ROGERS CENTRAL KITCHEN HVAC PROJECT

ADDENDUM #1

Date Issued: April 4th, 2025

ROGERS MS CENTRAL KITCHEN (B#24-025) ADDENDUM 1 SPECIFICATION NARRATIVE

MECHANICAL FIRST FLOOR PLAN M-201

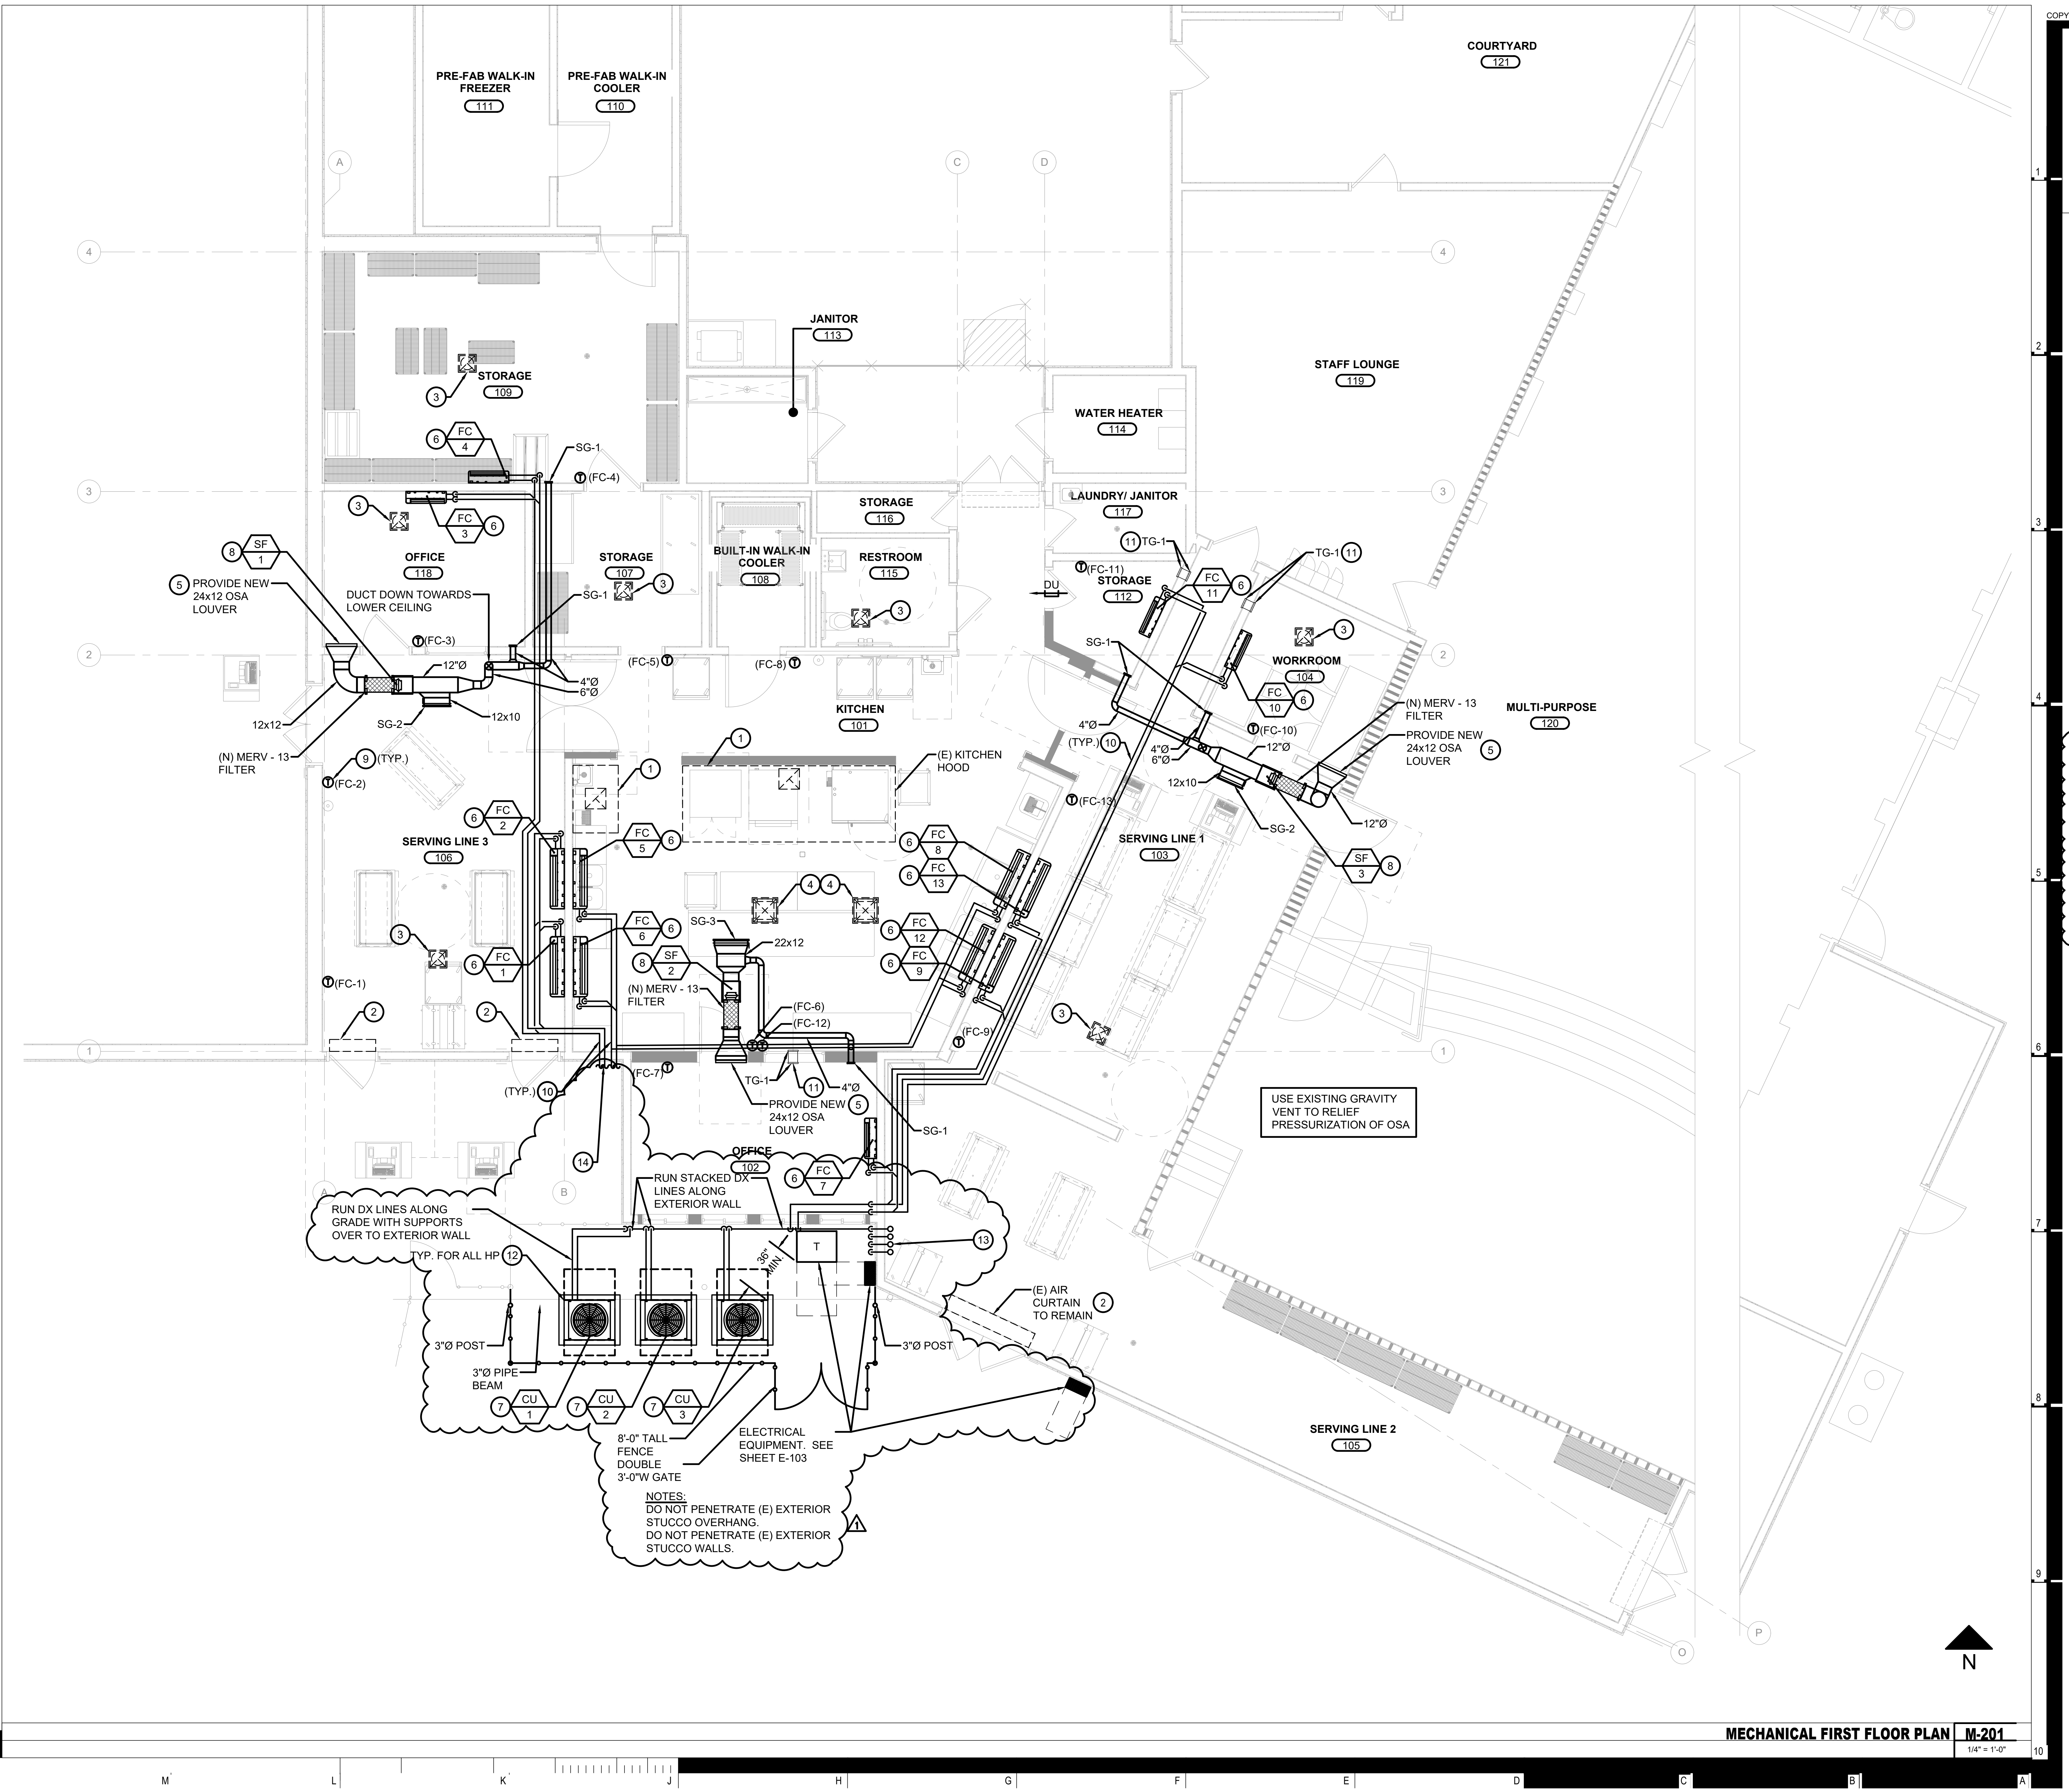
5. M-201 MECHANICAL FIRST FLOOR PLAN

- a) Added Remodel Keynotes 13 and 14.
- b) Relocated outdoor CU units so they aren't underneath the existing overhang.
- c) Revised refrigerant piping routing.
- d) Added note to not penetrate existing exterior stucco overhang or existing exterior stucco walls.
- e) Added in fenced enclosure and gate information.
- f) Relocated Electrical equipment shown for reference and coordination purposes.
